Sorell Council
 Development Application: 5.2022.184.1 -
 Revised plans - 297 Primrose Sands Road,
 Primrose Sands.pdf
 Plans Reference: P8
 Date Received: 22/12/2025

Allure Norfolk Bay

Attention: Planning Manager

In response to your email dated 9 April 2026 and earlier discussions, please find below a final submission for the above project, together with attachments of site plans for the project as advertised, final submitted site plan, comparison of the two plans and a google image of the farmlands to add context.

Allure Norfolk Bay
Master Plan
vN
50 100 150 200 250 500

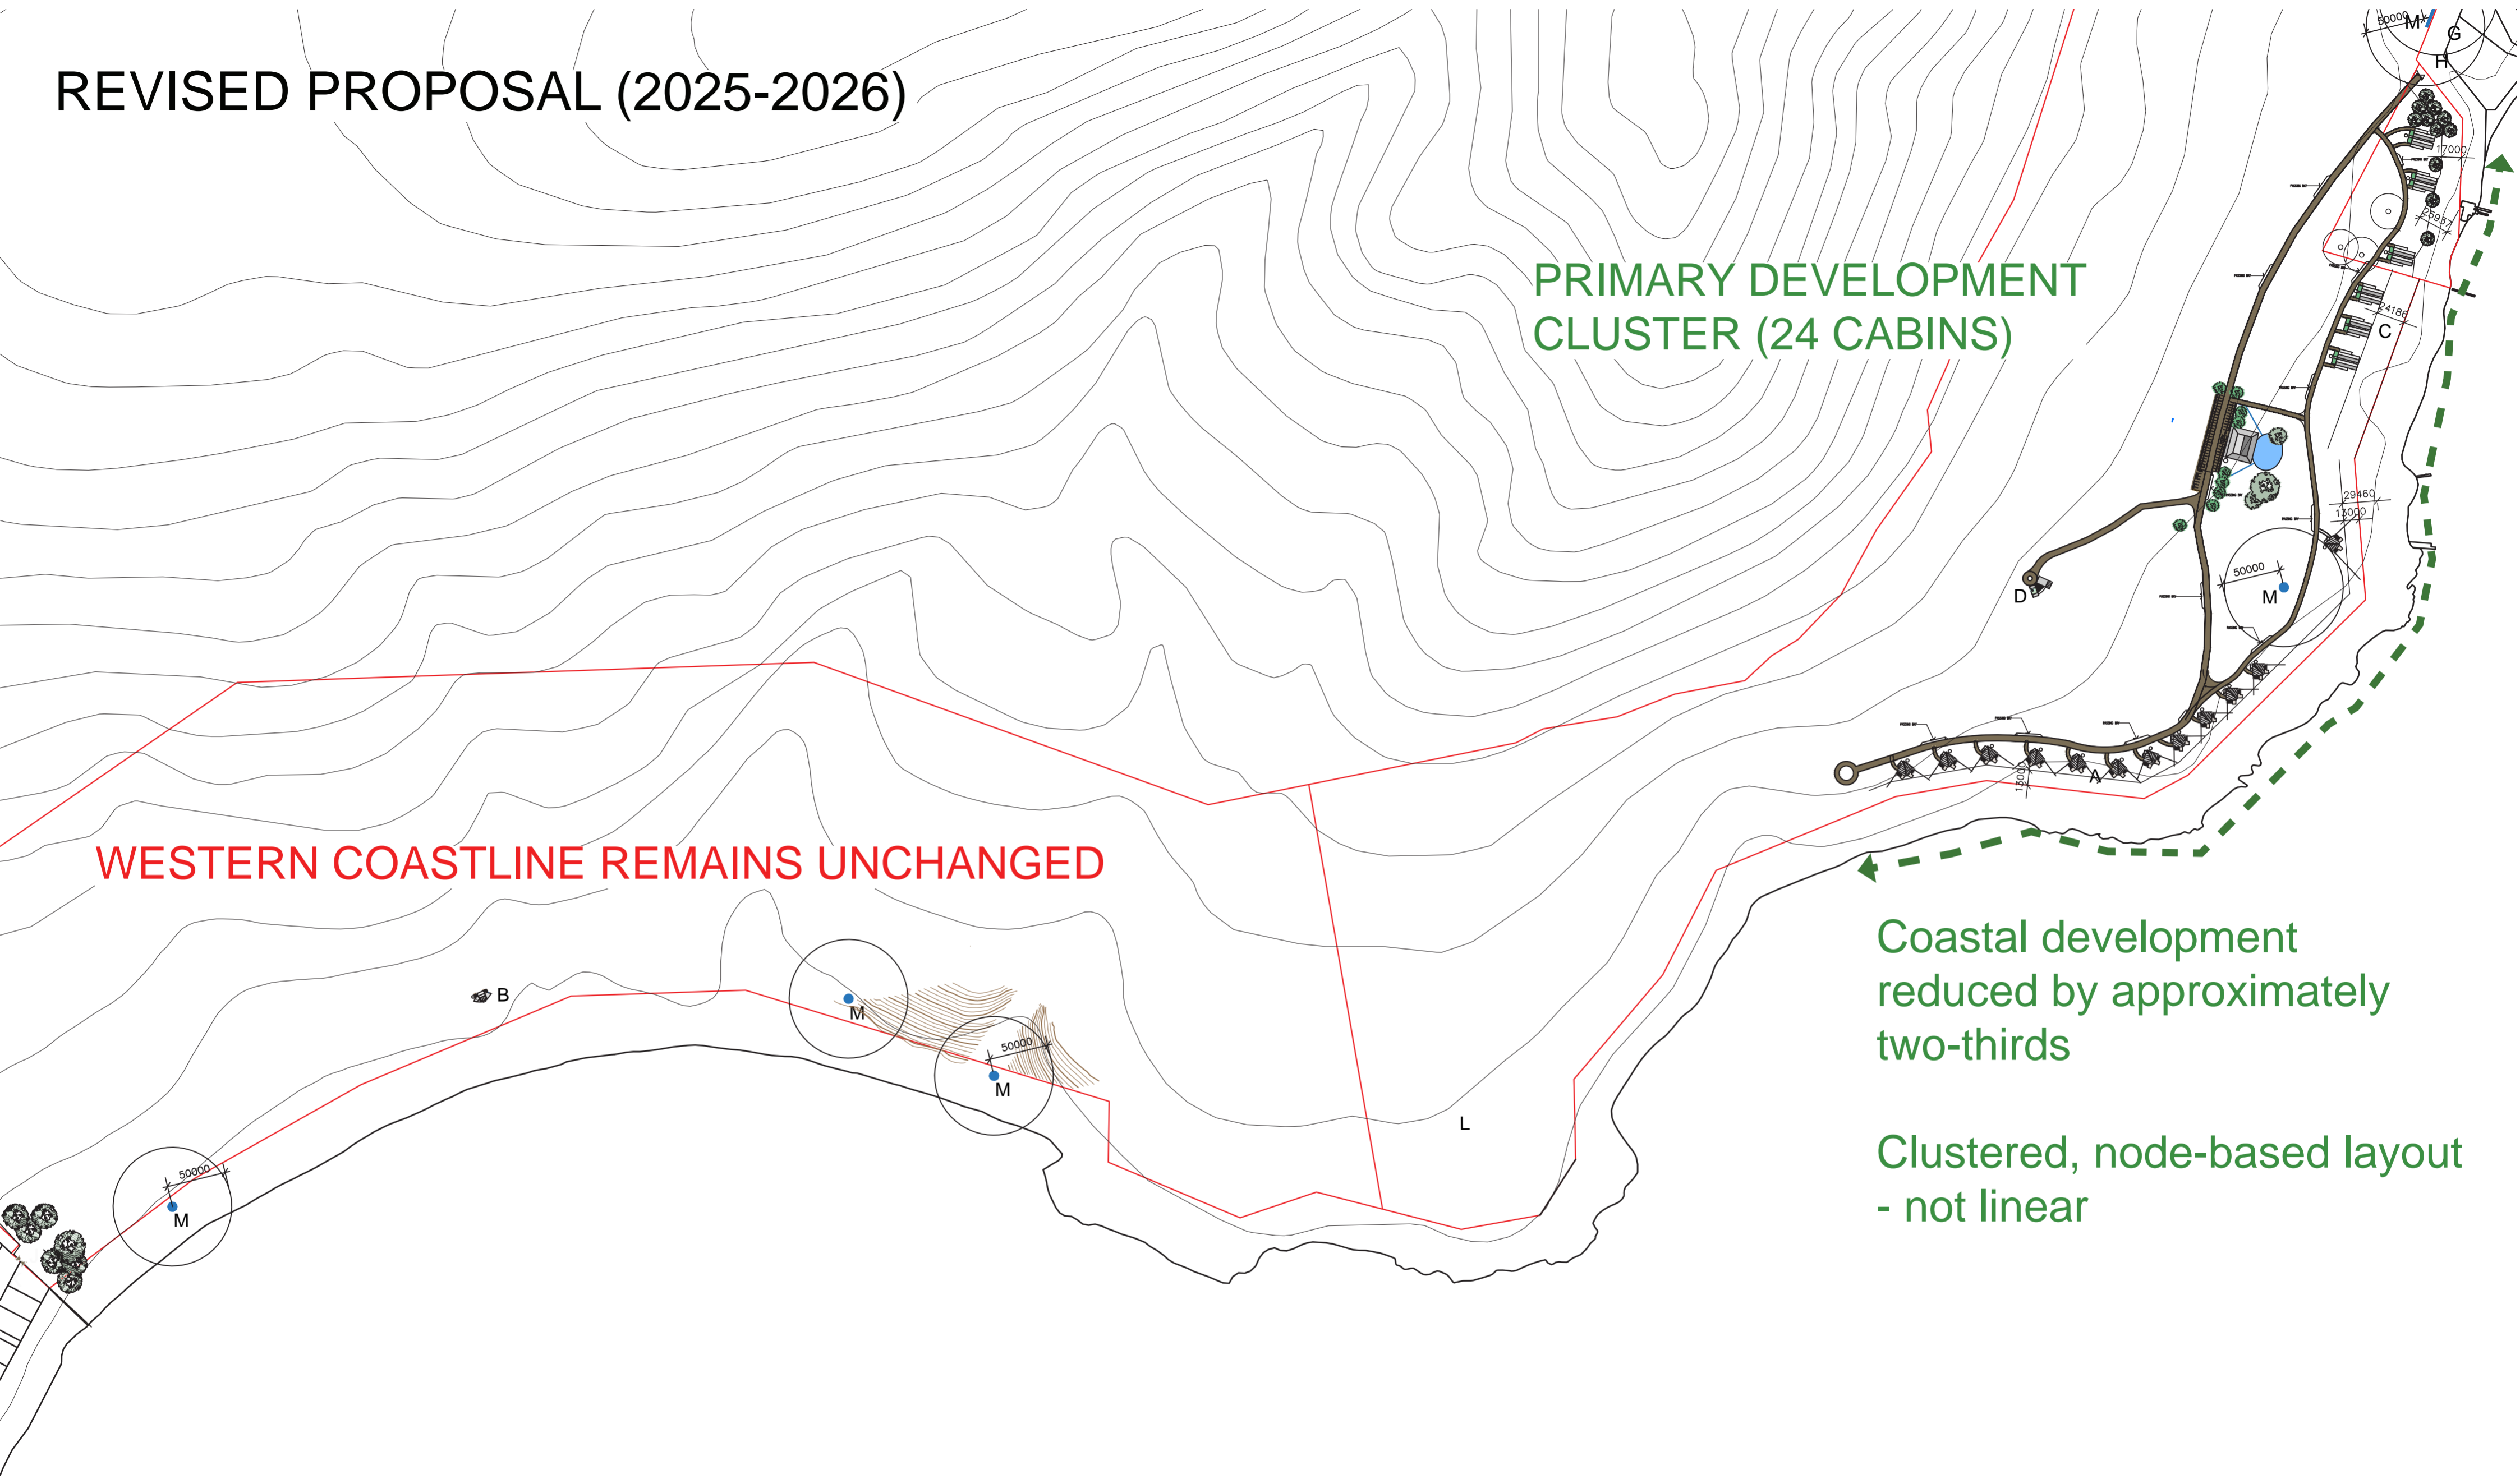
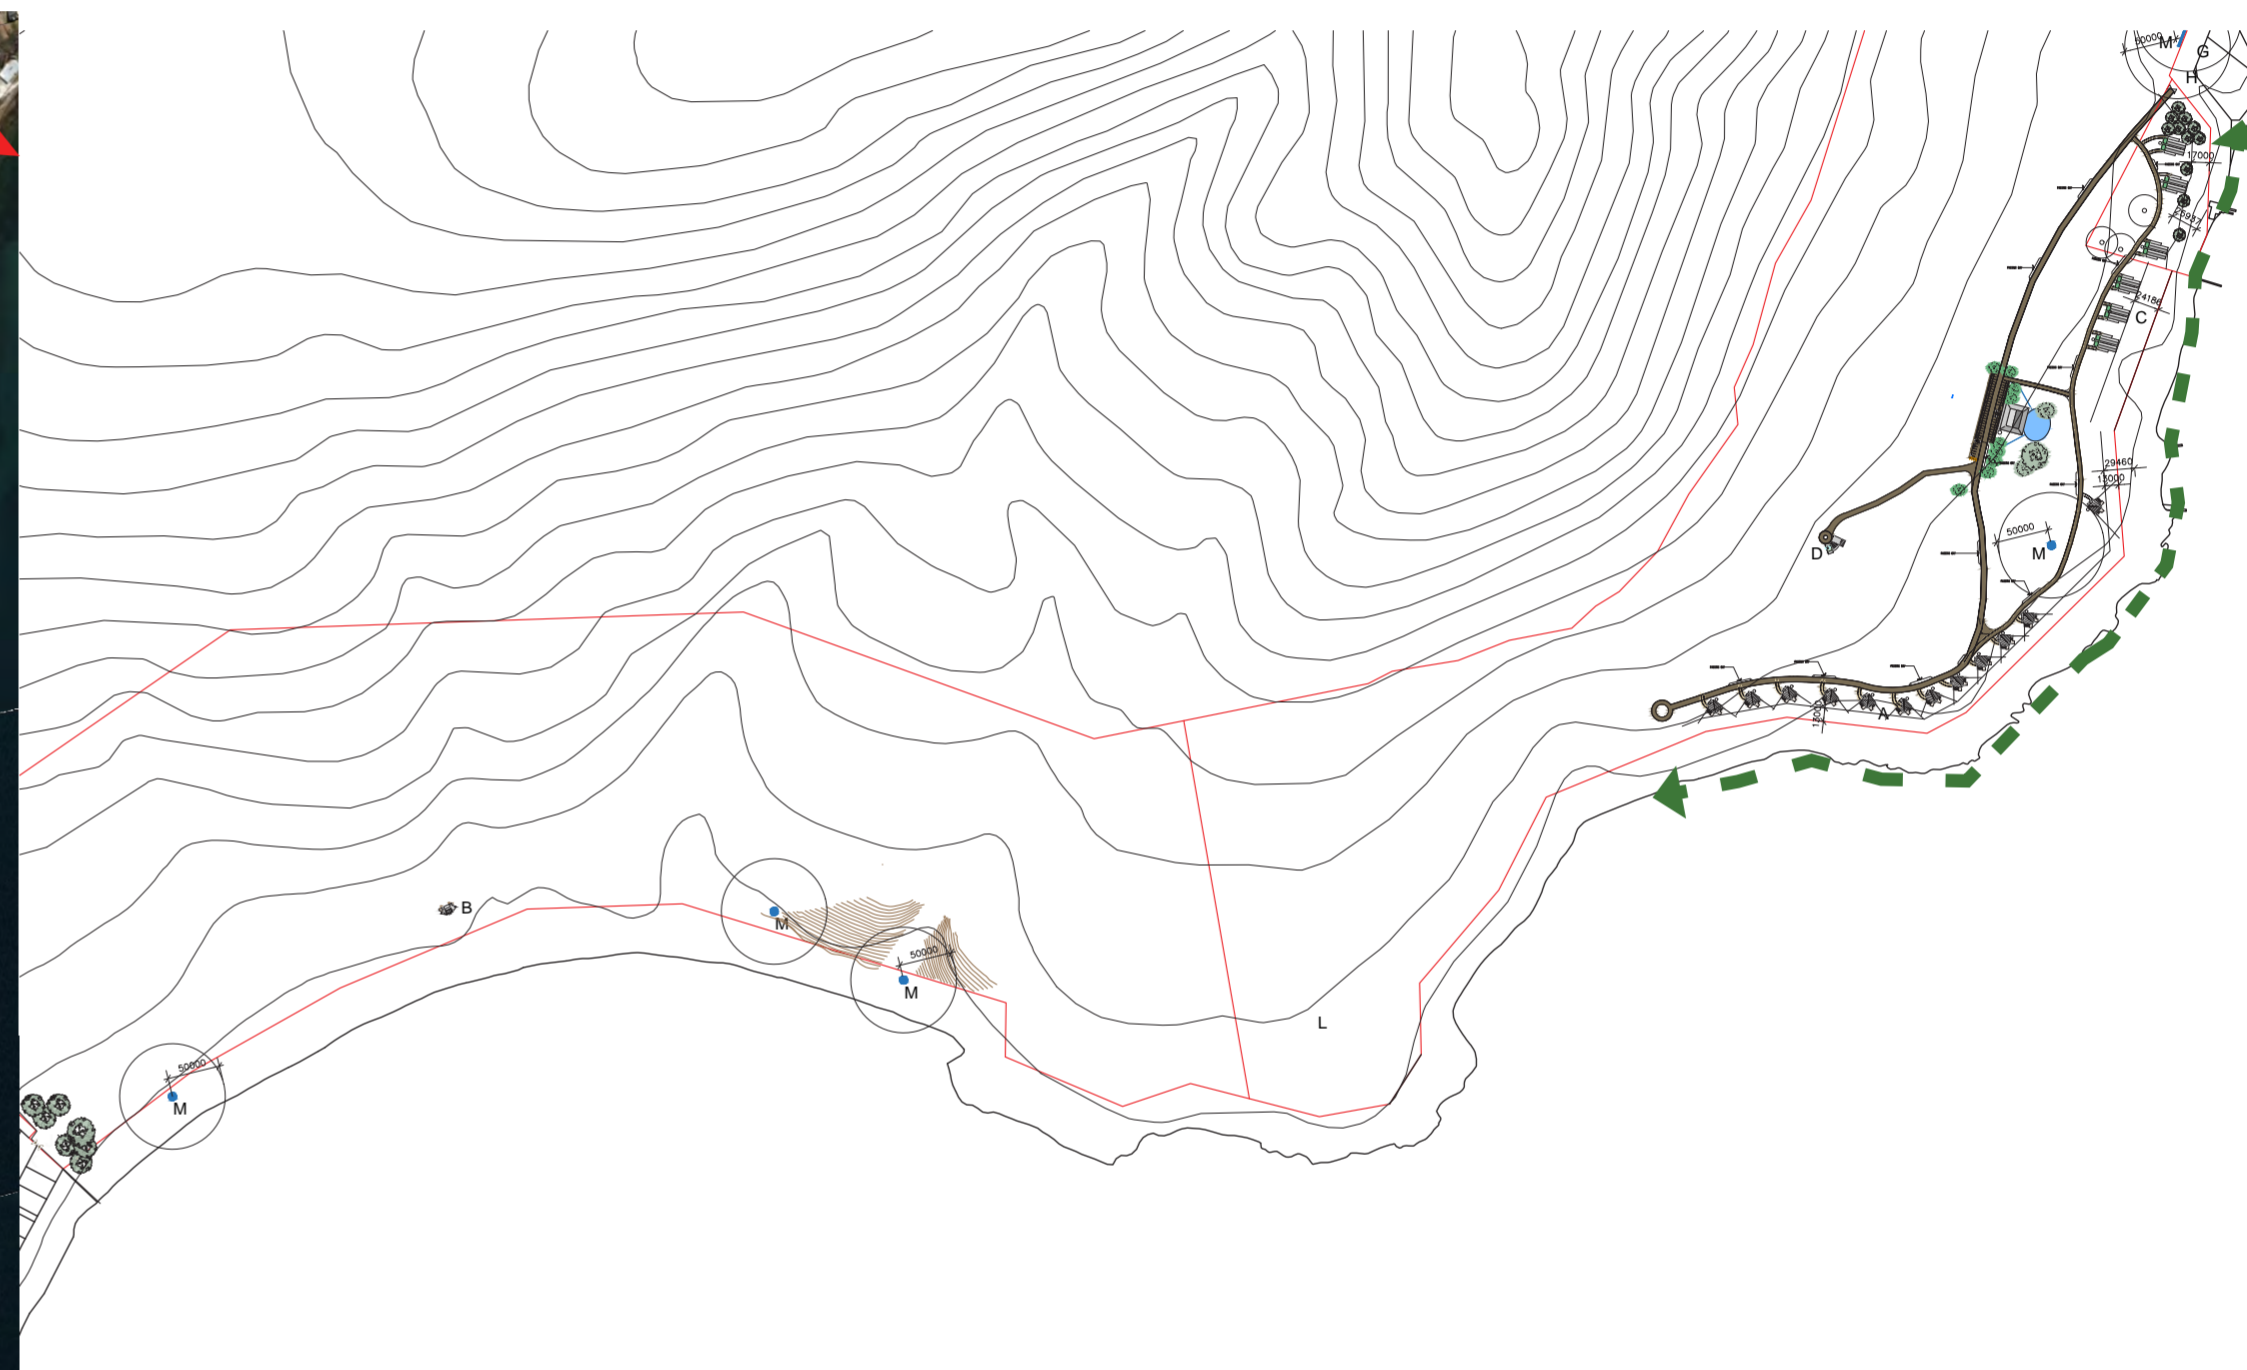
The most recent refinement, involving the removal of the remaining two cabins from the western extent of the site, further reduces the footprint of the proposal and does not introduce any new impacts. It represents a continuation of the same design response, namely, reducing spread and consolidating development and directly addresses a concern raised by Council.

The revised proposal now establishes a fully consolidated, clustered, node-based pattern of development, with all accommodation located within the eastern portion of the site. The western coastline is retained entirely in an undeveloped state. This represents a clear departure from any perception of a linear or ribbon development pattern.

Accommodation
East: Cabin Type A 12
Cabin Type D 12
West: No new Cabins
Total 24
(excludes existing cabin)
